CITY OF SAN ANTONIO  
**DEVELOPMENT SERVICES DEPARTMENT**

Re: **Krause Tract**

**MDP # 007-12**

**KRAUSE TRACT**  
 SAN ANTONIO, TEXAS  
 51.054 ACRE TRACT  
 MASTER DEVELOPMENT PLAN

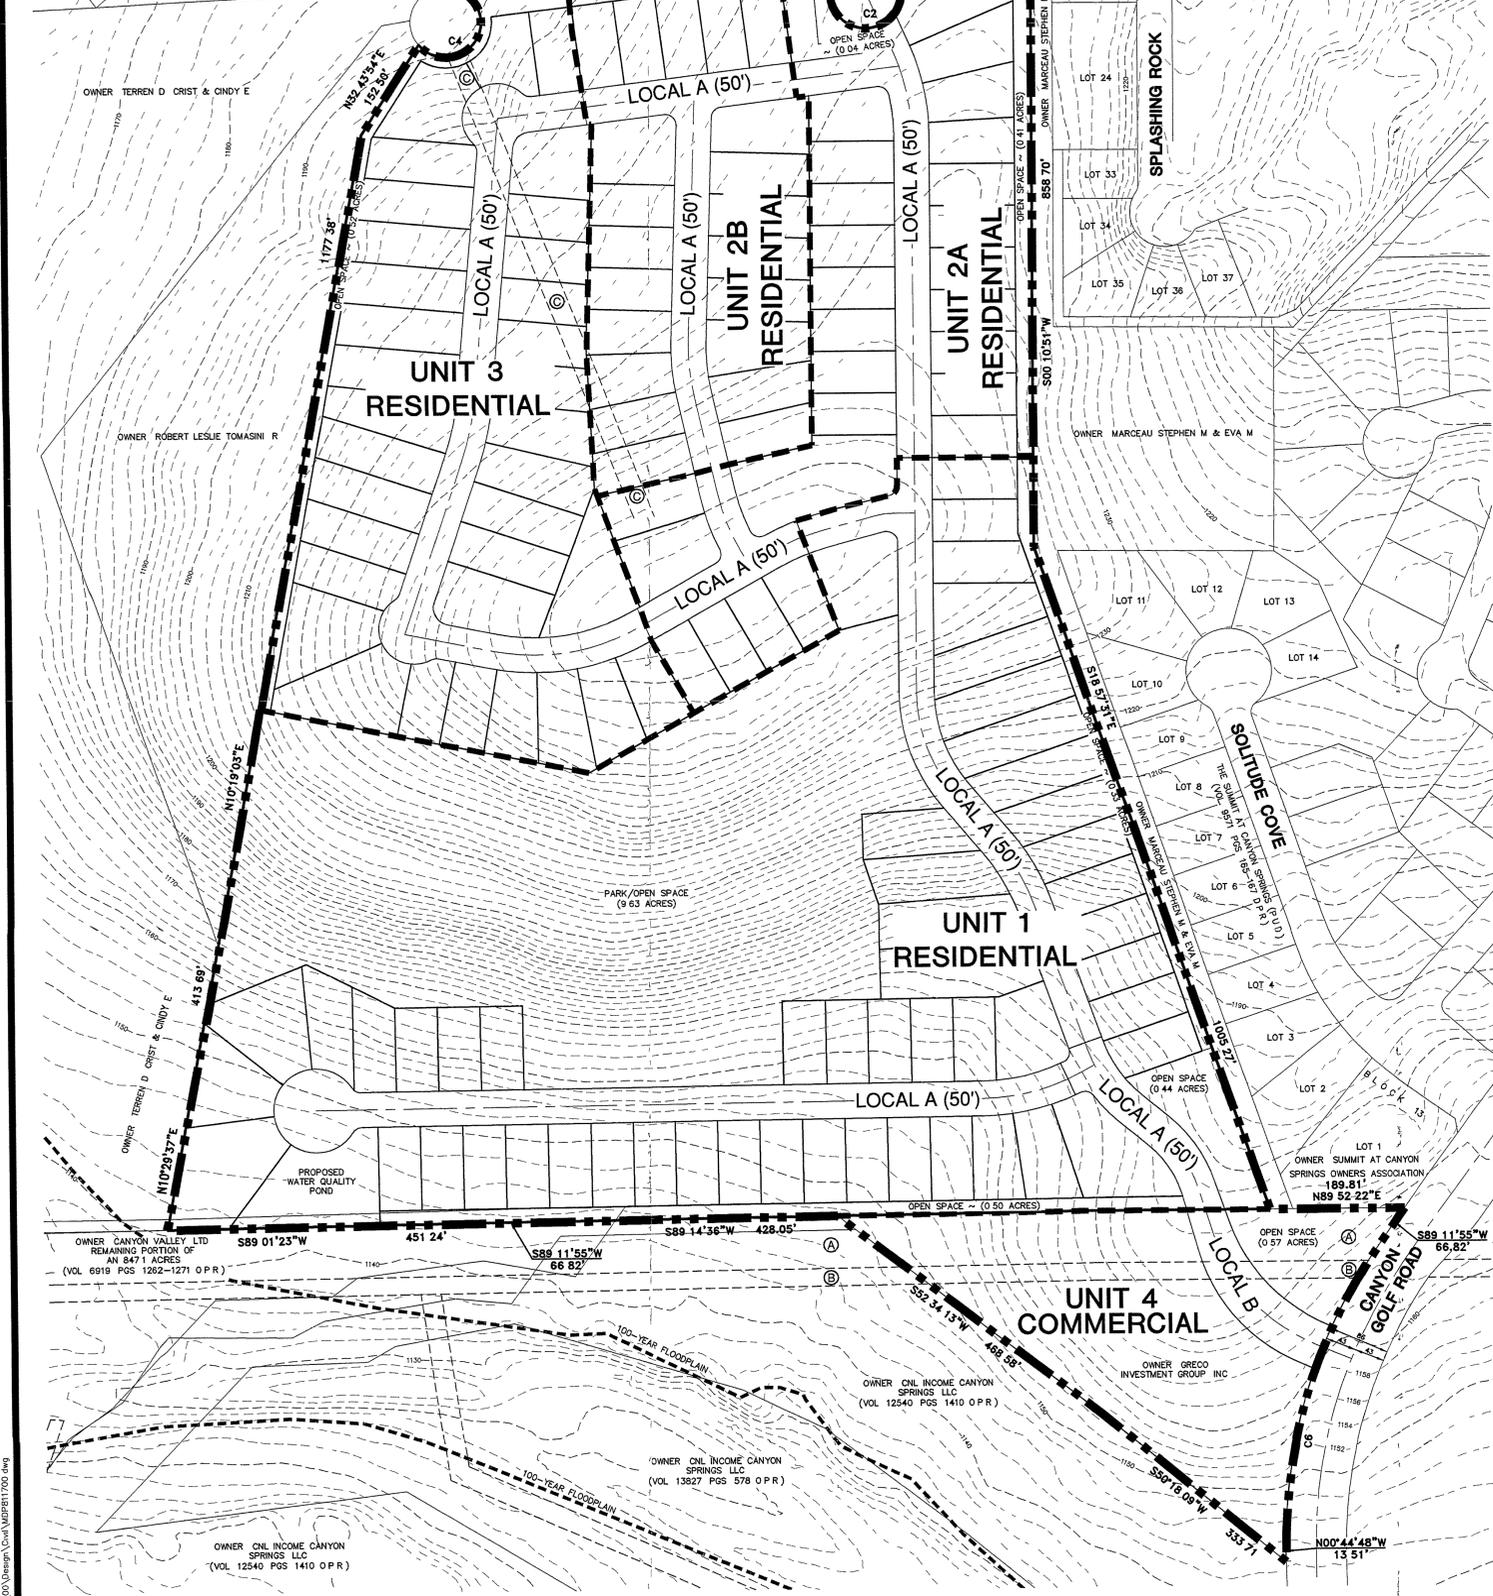
It will be expected that all of the property depicted in the Master Development Plan including but not limited to floodplains, drainage areas, and open space shall be platted. All platting shall comply with the Unified Development Code (UDC), the City's Master Plan, Major Thoroughfare Plan, and all applicable regulations for the City of San Antonio.

Please note that this action by the committee does not establish any commitment or support for the provision of drainage, utilities, services, or zoning of any type now or in the future by the City of San Antonio. In addition, it is suggested to work closely with the School Districts, so they can plan for the development accordingly.

The validity for this project shall expire within twenty-four (24) months from the date of acceptance in accordance with UDC §35-412(i)(1). Should you need further assistance, please contact Donna Camacho, Planner, at (210) 207-5016.
